# Manual Supplement

Manual Title:	789 Calibration	Supplement Issue:	<b>2</b>
Part Number:	1988891	Issue Date:	5/04
Print Date:	September 2002	Page Count:	2
Revision/Date:

## Change #1

Figure 2. Verifying Loop Power

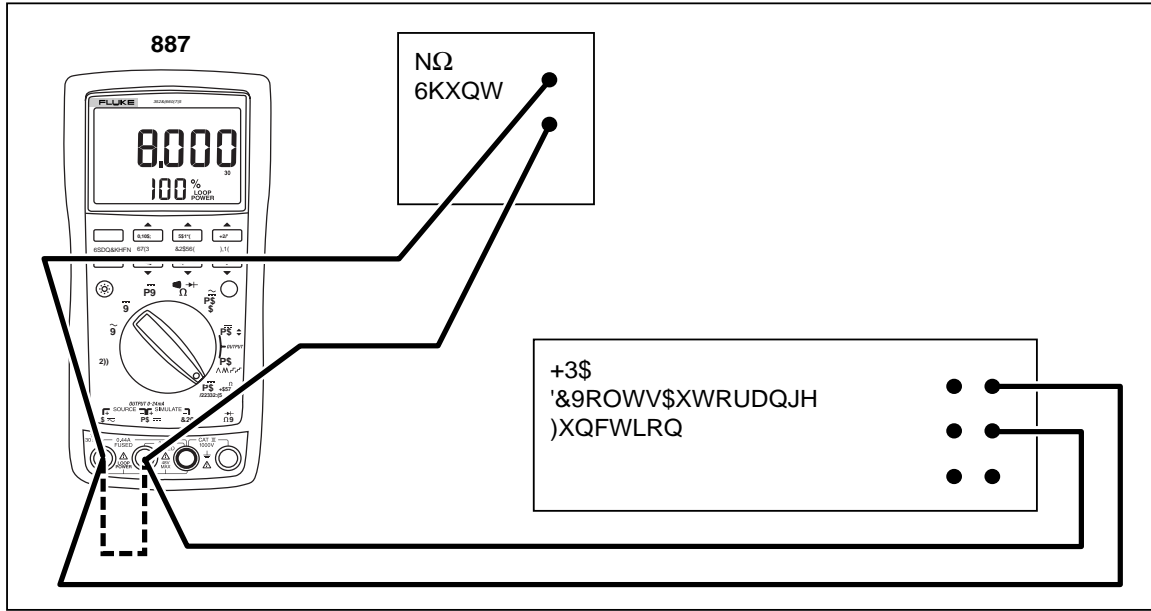
On page 12, replace the **Loop Power** procedure, and Figure 2 with the following:

1. Enable the dc volts autorange function of the HP3458A multimeter.
2. Connect the 1-k $\Omega$  shunt across the UUT **SOURCE** outputs.
3. Turn the rotary knob of the UUT to **LOOP POWER**.

4. Measure the open circuit voltage of the UUT and verify it is greater than 29.8 V and less then 32 V.
5. Press the blue button on the UUT to enable the 250  $\Omega$  HART resistor.

6. Repeat step 4.
7. Disable the 250  $\Omega$  HART resistor by pressing the blue button.
8. Connect the 1-k $\Omega$  shunt across **SOURCE +** and **SOURCE -** of the UUT.

9. Measure the loaded down voltage and verify it is greater than 23.8 V and less than 32 V.
10. Remove the 1-k $\Omega$  shunt.
11. Disconnect the UUT from the multimeter and turn the UUT off.

12. Select the dc current function on the multimeter and set it to the 1-amp range (a 0.1  $\Omega$  shunt is used in the 1-amp range).
13. Connect the current input terminals of the multimeter to the **SOURCE +** and **SOURCE -** terminals of the UUT.

14. Repeat step 3.
15. Verify the short circuit current is greater than 25 mA and less than 35 mA.
